Engineering Change Notification

MFH-/JMFH-...-D-1/-2/-3-C solenoid valves Re-Design of pilot valves

Project No 262144

Project Title MFH/JMFH pilot valve

Previous Version

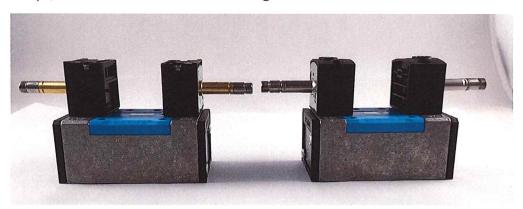
- The change affects the appearance of the solenoid plate, while keeping nearly same dimensions.
- The position of the armature tube is changed by less than 1mm.
- Material changes from brass and stainless steel on armature to stainless steel only.
- Operational behaviour can be affected due to possibly slightly increased valve switching times, but within existing tolerances (see below for further details).
- As the design of the pilot valve is changed, we also need to adjust statistical reliability data, especially B10 life cycle values. After the change, for all affected products, the B10 value is 10 Mio. SP (switching cycles). This will be documented in reliability data sheets.

MFH pilot valve, with armature, material brass and stainless steel

MFH pilot valve in new design, with armature, material stainless steel only
